# HEXAGON TRANSPORTATION CONSULTANTS, INC.

**Subject:** Response to County of Santa Clara's Review Comments Regarding Intuitive Surgical's Revised Site Plan in Sunnyvale and Santa Clara, California

**Re: *Response to Comments from the County and City of Santa Clara on the Memo Addressing Intuitive Surgical's Revised Site Plan in Sunnyvale and Santa Clara, California***

Figure 2  
Project Driveways and Trip Distribution

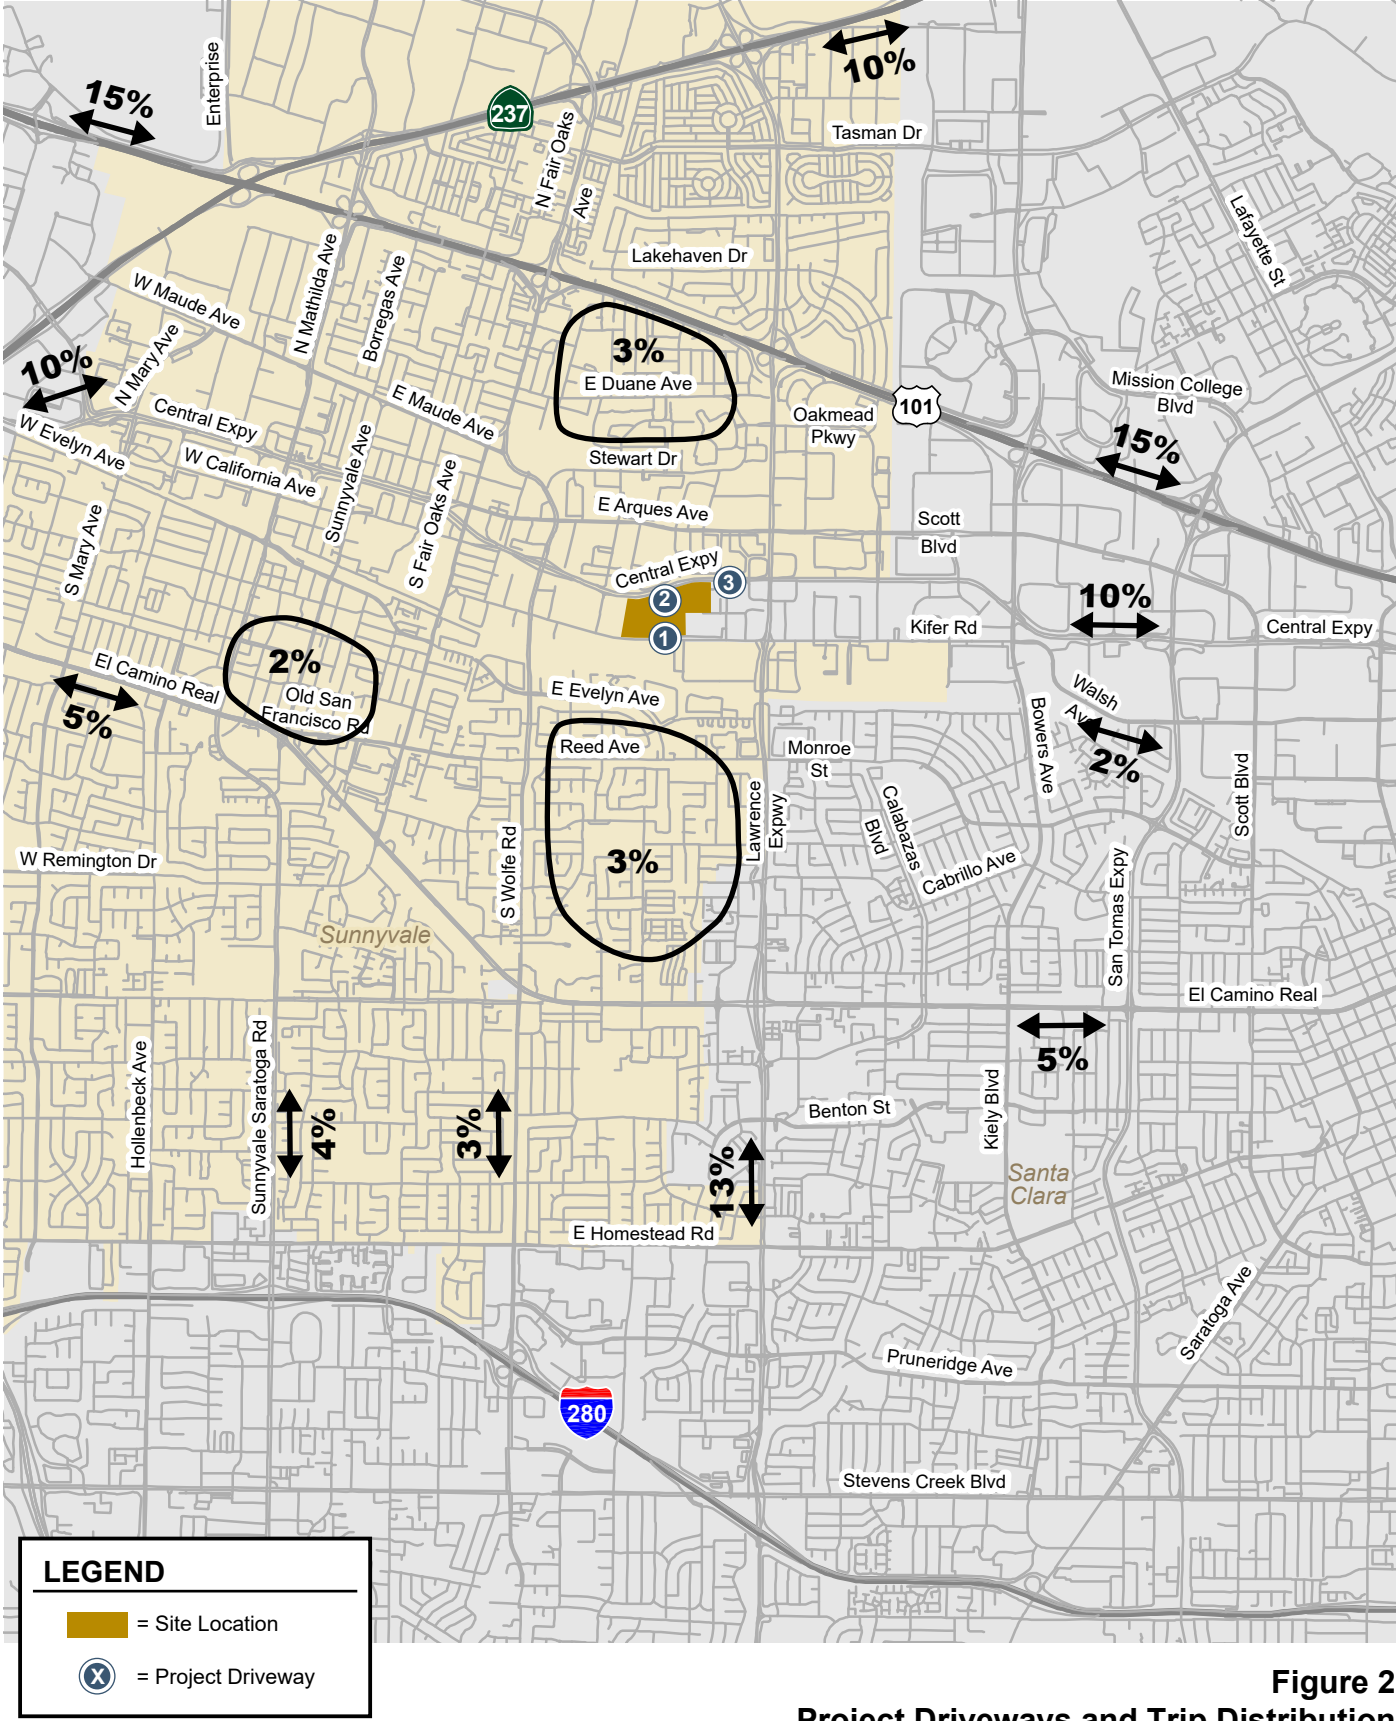
1. **Comment:** Kifer Road/ Project Driveway (Intersection #1) should be a 4-leg intersection and Could you revise the map to reflect that?

**Response:** The figure was revised in the memo.

**Figure 3**  
**Project Generated Trips at Driveways**

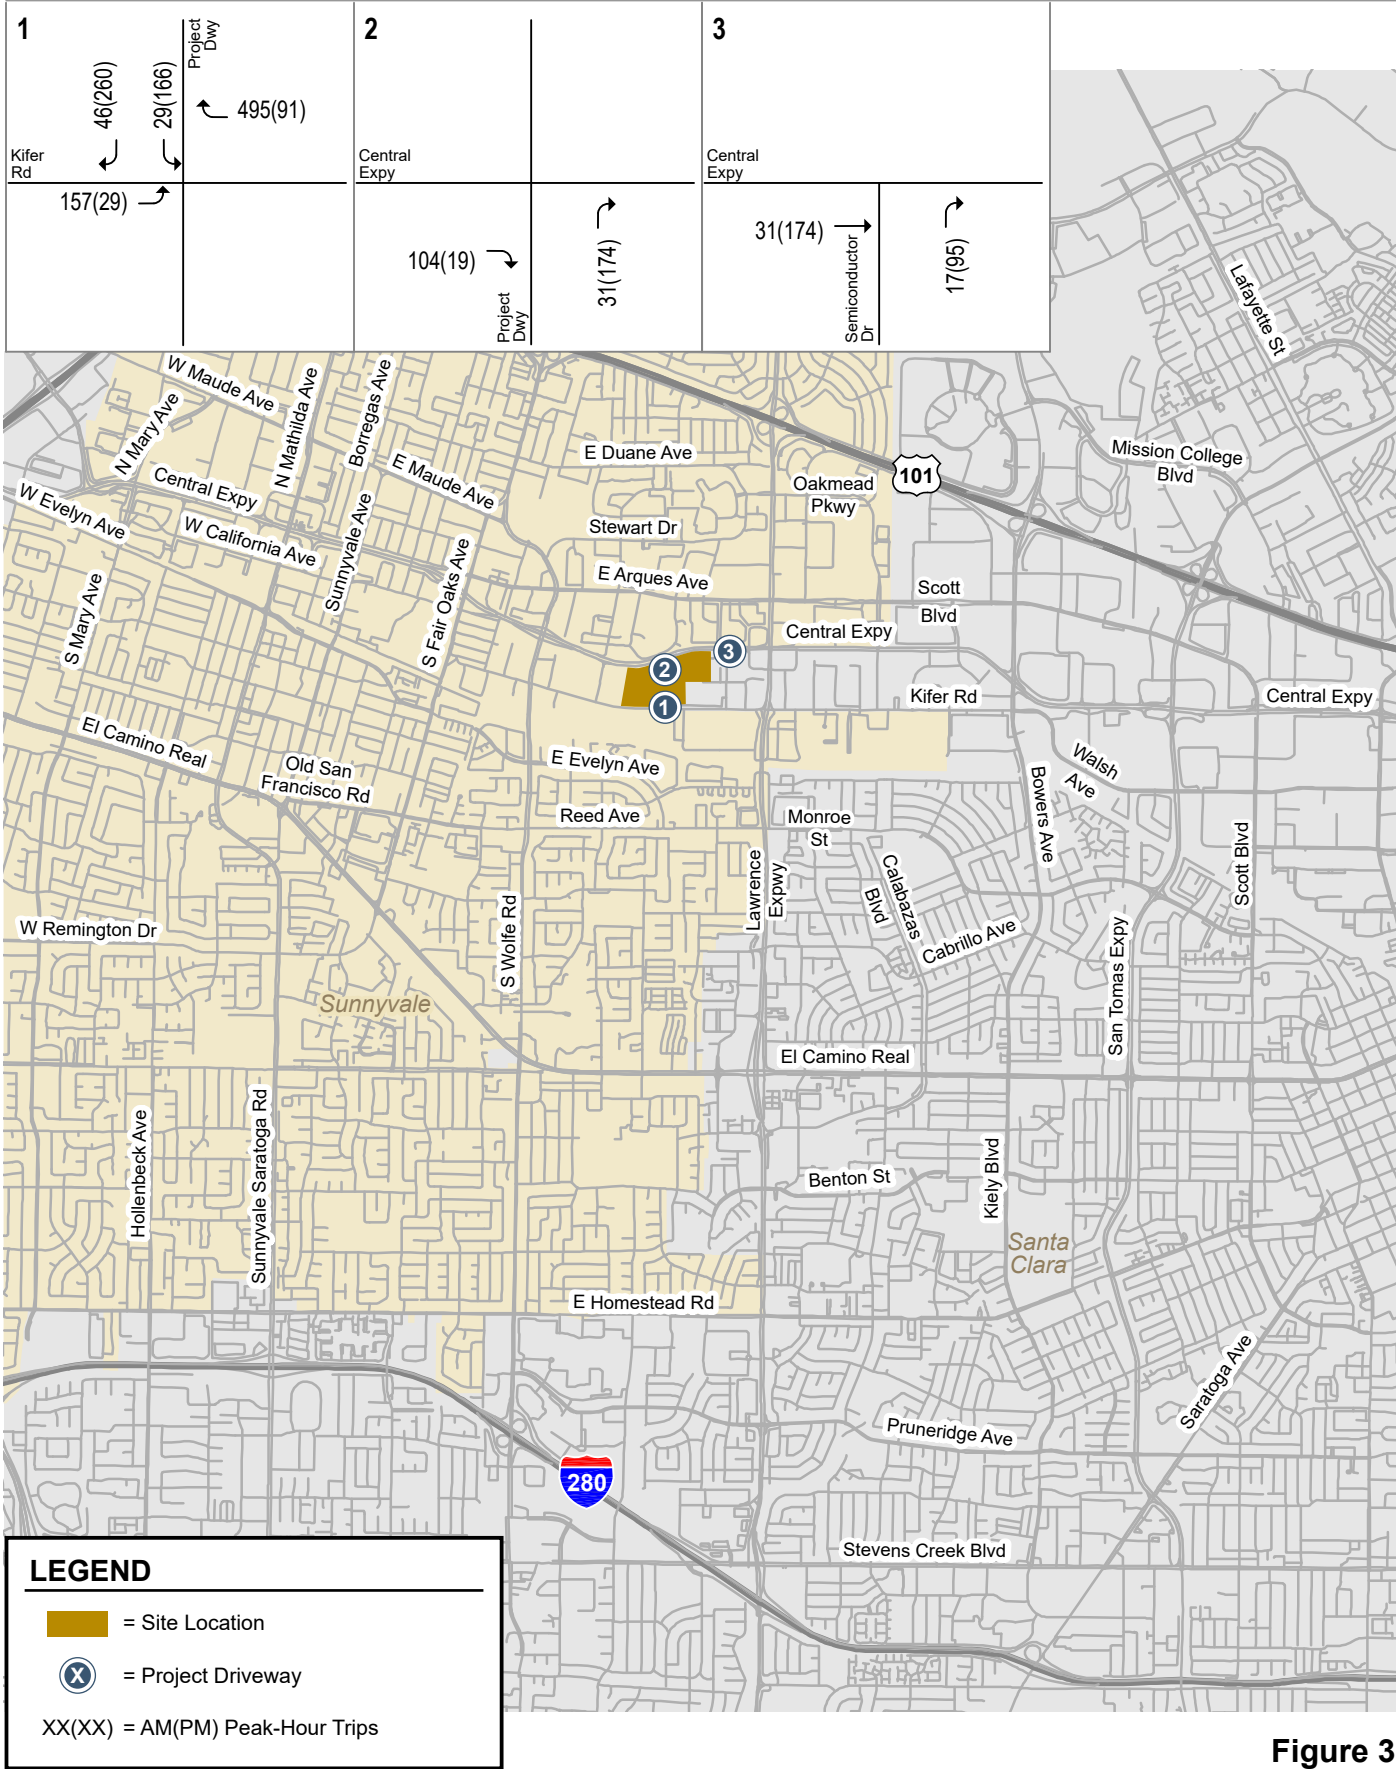
2. **Comment:** The trip distribution and assignment should be looked over again and modified as it seems that vehicle trips would utilize Central Expressway instead of Kifer Road to access the project site. The travel time on Kifer Road would be much slower and less attractive to vehicle trips than taking Central to access the site.

**Response:** Google Maps showed that the travel times and distances between the paths using the driveways on Central Expressway versus Kifer Road are similar. It would also be a conservative approach to assign trips onto the local roadway network.

Figure 4B  
Project Site Gate Locations

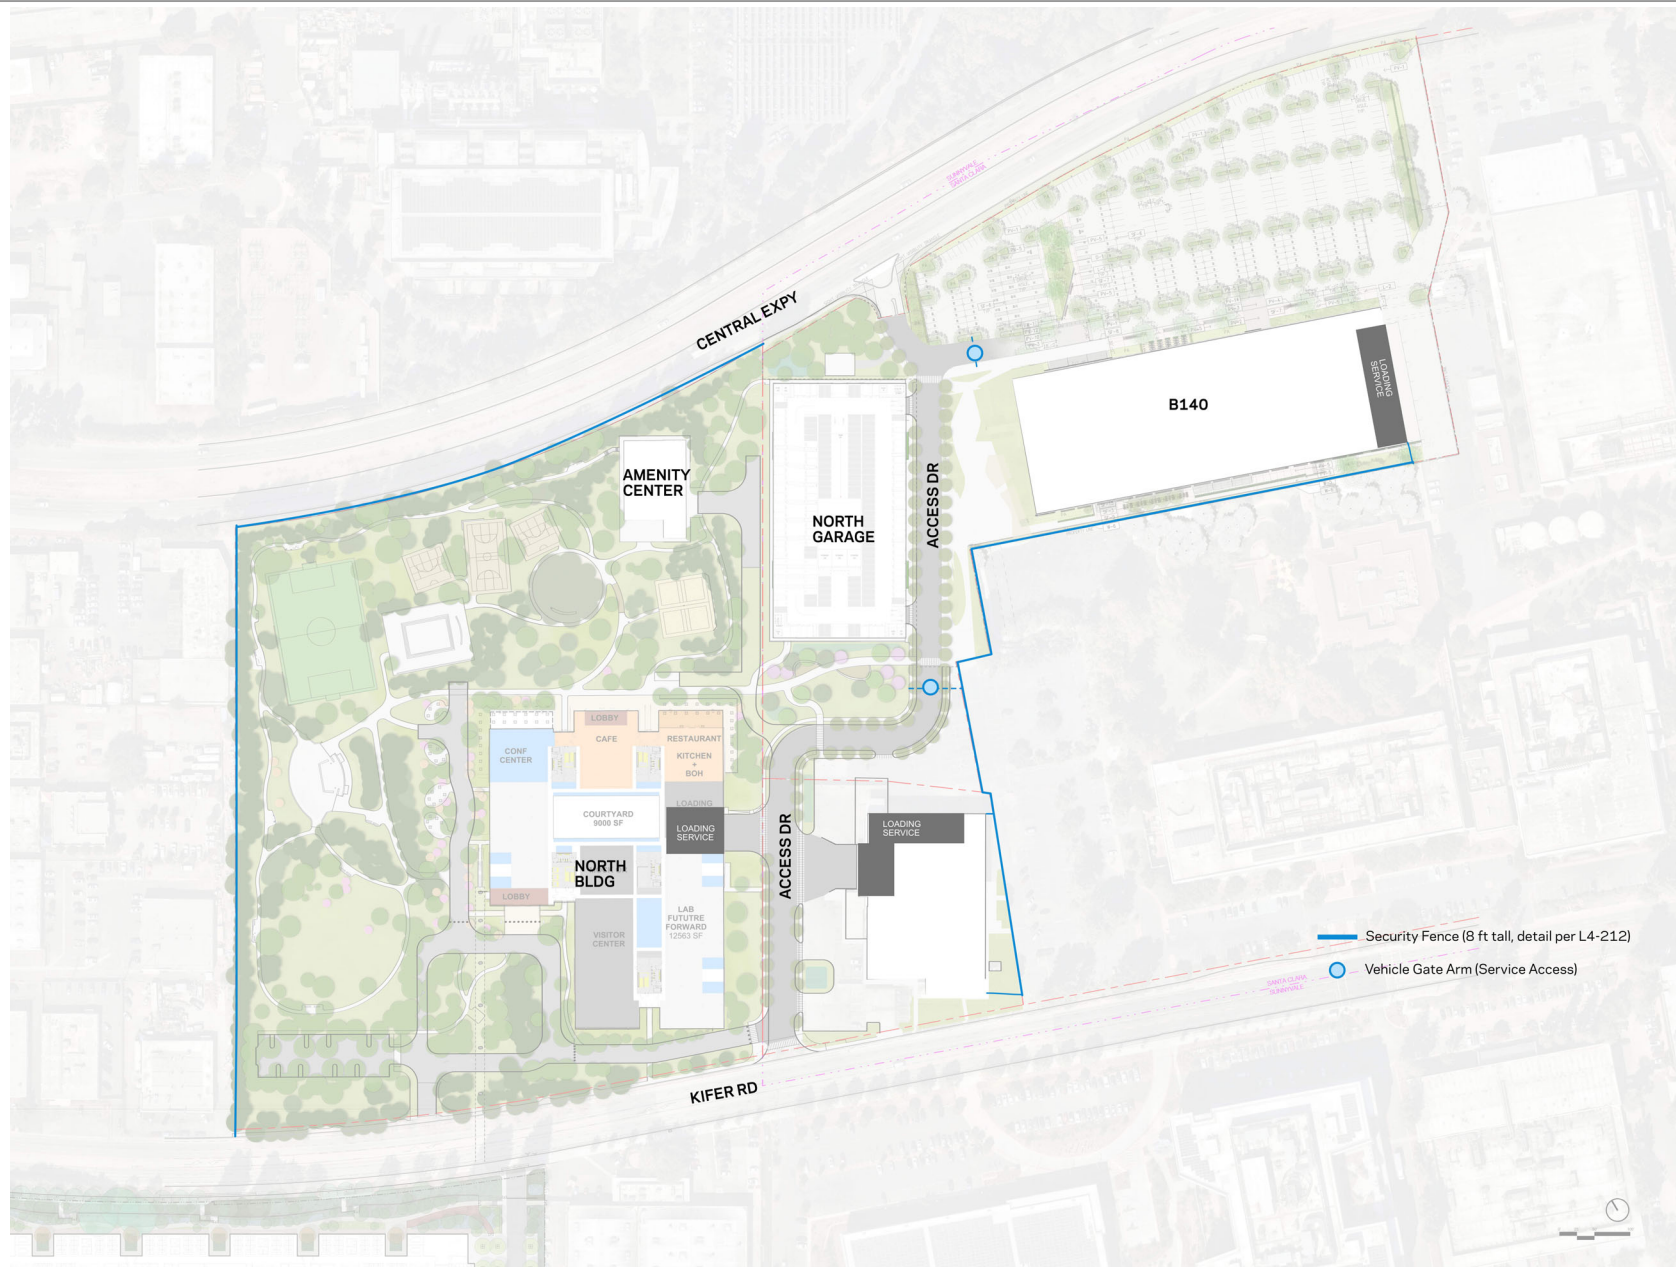
3. **Comment:** Please show where the gates would be located for both parking structures on the site plan as it is mentioned in the memo that remote controlled gates would be included at the entrances to the stand-alone parking garage and the surface lot on the site.

**Response:** Figures showing the gate locations were added to the memo.
